Safety Evaluation Report

Renewal of the Facility Operating License for the
Armed Forces Radiobiology Research Institute
TRIGA Reactor

License No. R-84
Docket No. 50-170

U.S. Nuclear Regulatory Commission

Figure 2-2 The AFRRI TRIGA RELAP5 model

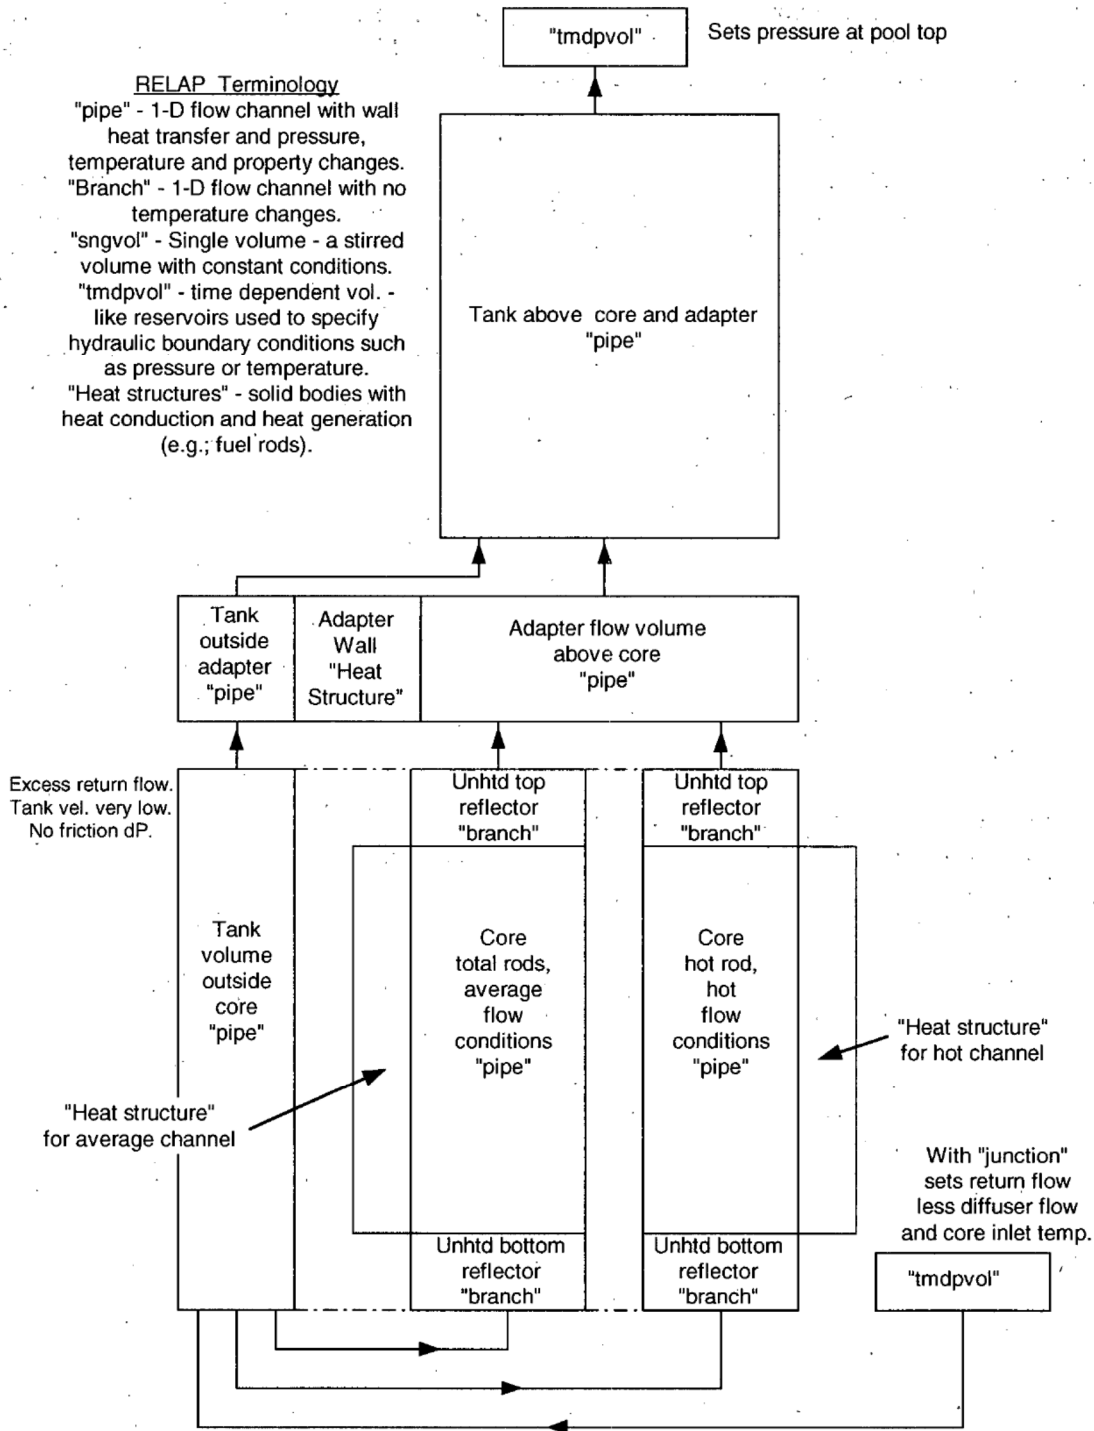
The licensee presented an analysis of the AFRR1 TRIGA DNBR using the Reactor Excursion and Leak Analysis Program 5 (RELAP5)-3D (Ref. 2). The methodology and computer codes used for this analysis have been compared to actual measurements and consistently produce conservative results. The NRC staff considers the use of RELAP5 with the Bernath correlation to determine the critical heat flux (and thus departure from nucleate boiling) to provide a best estimate analysis of DNBR. The licensee's thermal-hydraulic design report describes the basic features of the licensee-supplied model used in its analysis. Figure 2-2, reproduced from that report, illustrates the basic features of the model, which includes a hot channel with its associated coolant and heat structure (the hot fuel element). There is also an average channel that represents the remaining fuel, fuel followers, and the associated coolant inside the reactor core. The channels are connected to a riser section that directs the coolant flow away from the top of reactor core into the reactor tank and then into the downcomer structure. The returning flow is directed into the reactor core near the bottom of the reactor tank.

The model assumes that there is no crossflow between adjacent channels. This assumption is conservative because higher values of temperature and lower margins to the DNBR are typically predicted when crossflow between adjacent channels is ignored. RELAP5-3D is used to calculate the steady-state natural circulation flow through the water channels adjacent to the fuel elements. The code also calculates all radial heat transfer from the fuel element into its associated coolant channel. Accordingly, the code calculates the cladding and fuel axial and radial temperature distributions as well as the axial temperature distribution in each coolant channel.

The RELAP5 model used by the licensee is based on a circular arrangement of fuel elements. The model also includes a representation for the shroud, which extends 5 feet (1.5 meters) from the core top grid plate. The water exiting the top of the core shroud enters the reactor pool water. The pressure at the top of the reactor core is sum of atmospheric pressure at top of the pool plus the hydrostatic pressure associated with the water column above the core at this elevation. The core height plus the adapter height provide the buoyancy head for natural circulation of water inside the reactor tank and the core region.

Figure 2-4 The 85-3 core loading

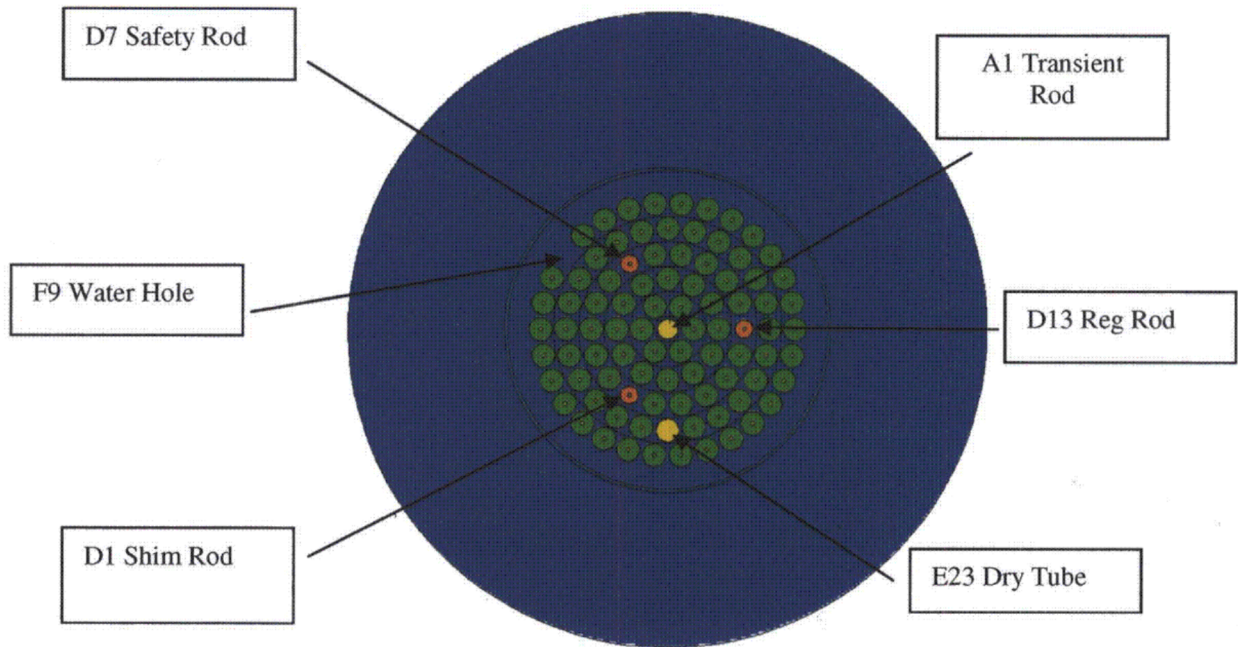
The licensee calculated the hot channel geometry as follows (see Figure 2-4):

The tri-cusp area between the core center rod, A-1, and two adjacent B ring rods forms the minimum flow area in the core and includes the maximum power rod. The three rods that form this tri-cusp flow area constitute one-half of a rod. Additionally, the heated perimeter for this flow area represents only one-third of a rod because the central location A-1 is not a fuel rod. Customarily, this area is doubled to represent the flow area and hydraulic diameter for a whole rod. The flow area then represents two-thirds of a heated rod. Input to RELAP5 for the "maximum rod" is two-thirds of a rod surface area and two-thirds of the hot rod power.

Although it is true that the central thimble provides no power for the cell described, this is the limiting channel to consider for the DNBR analysis (Figure 2-5). Scaling the flow area and power to a full fuel element shows that this channel is more limiting than the channels with more fuel elements. This is further discussed below in Section 2.6.1 of this SER under "Confirmatory Analysis."

Figure 2-5 AFRR I hot coolant channel model

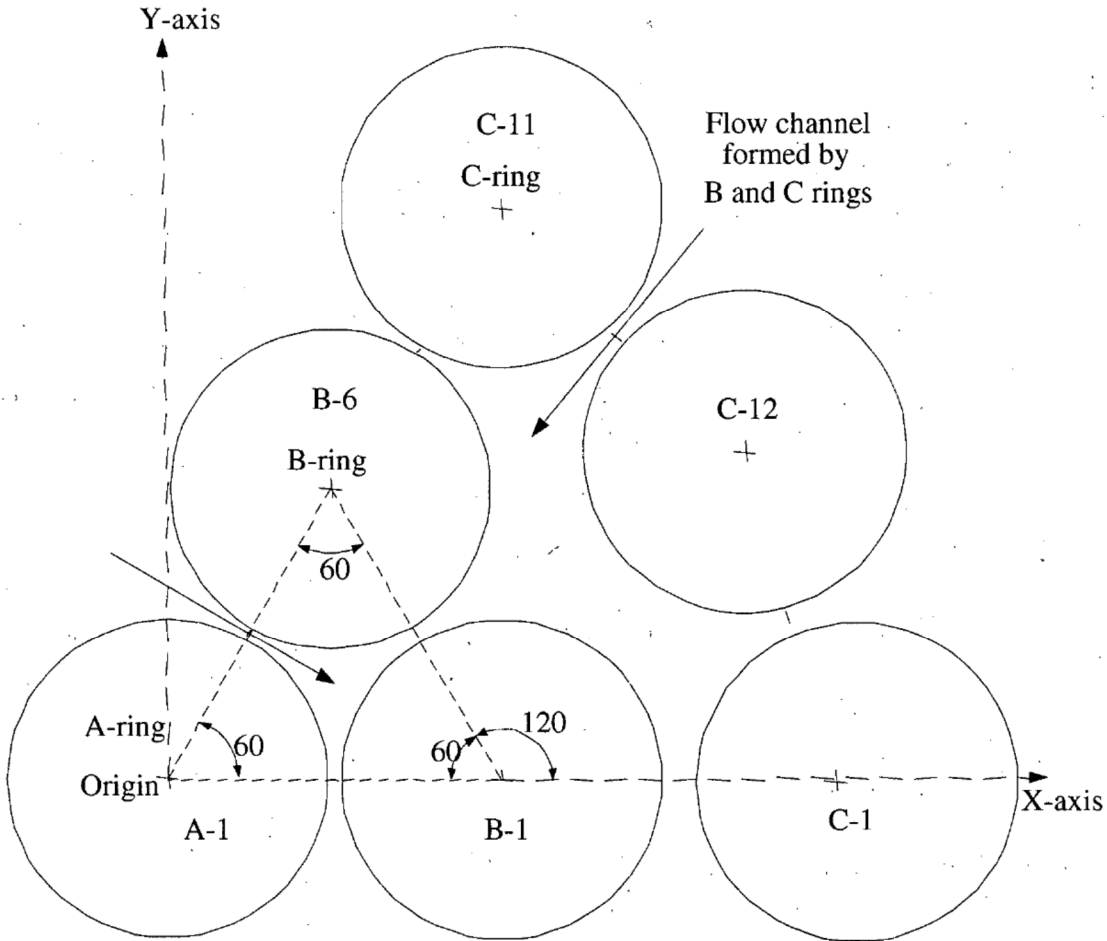
The RELAP5 model of both the average and hot fuel elements contains the heated fuel and the unheated sections below and above the heated section. These unheated sections represent the reflectors and the fuel element end fittings. A single inlet flow loss coefficient represents the flow losses associated with the bottom grid plate and the bottom fuel element fittings, which is estimated by calculating the individual contraction and expansion losses from the tank through the lower core distribution plate into the reactor core. The sum of these losses is then converted to the single inlet loss coefficient based on the flow area. A similar calculation is performed for the exit loss coefficient that represents the hydraulic losses due to flow expansions and contractions from the top of the fuel element, through the grid plate and into the adapter flow region.

The applicant stated that the fuel element is 1.475 in (3.75 cm) in diameter, and the fuel meat is 15 in (53 cm) long. The fuel element is represented in the heat structure by 25 discrete axial nodes and 20 discrete radial nodes. The NRC staff notes that this radial dimension is different by 0.002 in (0.1 cm) from the AFRR I drawings which show this dimension to be 1.473 in (3.74 cm). Information obtained from GA indicates that it should be 1.478 in (3.76 cm). This is discussed more fully under DNBR - Confirmatory Analysis below.

Figure 1. Organization of Personnel for Management and Operation of the AFRRRI Reactor Facility

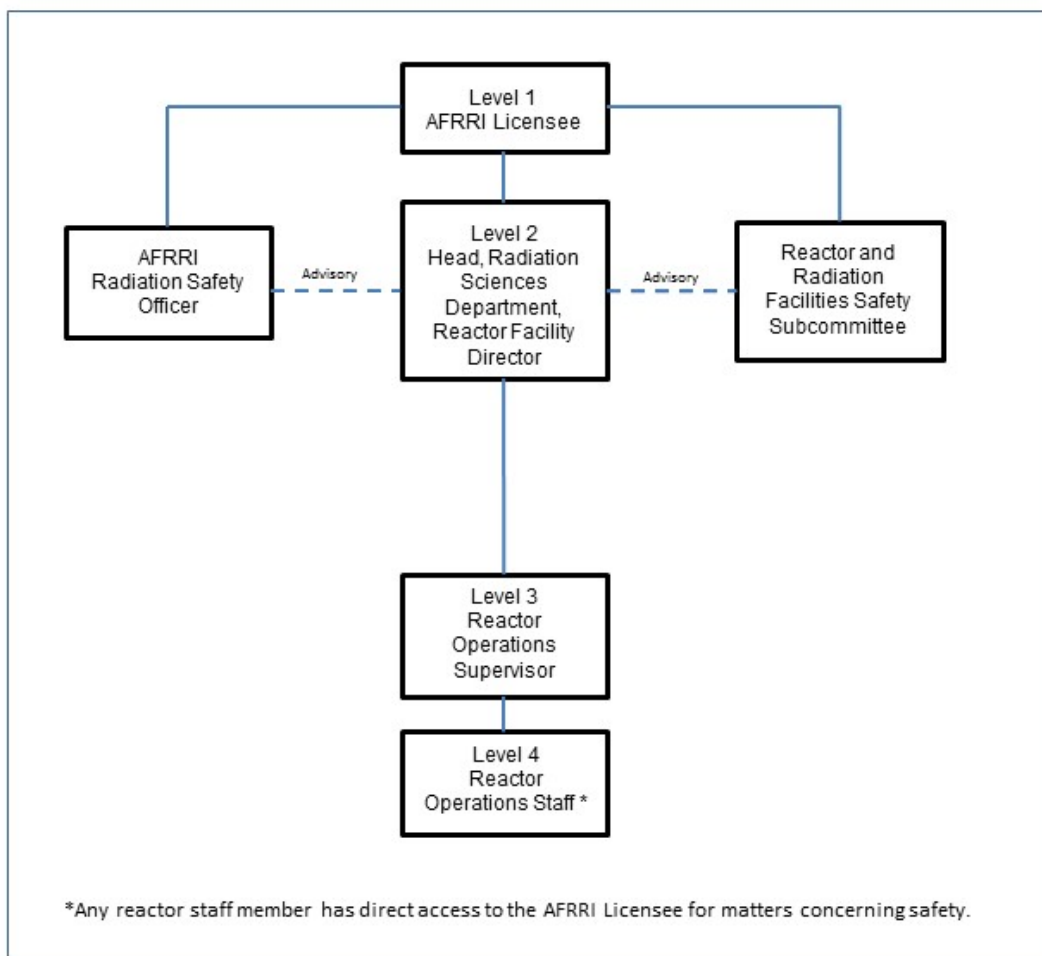
In TS 6.1.1, the licensee has identified the responsibilities and organization of individuals associated with the facility. TS 6.1.1 helps ensure that the AFRRRI organization structure and responsibilities are maintained. The NRC staff reviewed TS 6.1.1 and finds that the AFRRRI organizational structure described in TS 6.1.1 and shown in TS 6.1.1, Figure 1 is consistent with the guidance in NUREG-1537 (Ref. 39) and ANSI/ANS-15.1-2007 (Ref. 64). Additionally, the NRC staff finds that TS 6.1.1 meets 10 CFR 50.36(c)(5), which requires, in part, that licensees have TSs on administrative controls related to organization and management necessary to assure safe operation. On the basis of its review of the information above, the NRC staff concludes that TS 6.1.1 is acceptable.
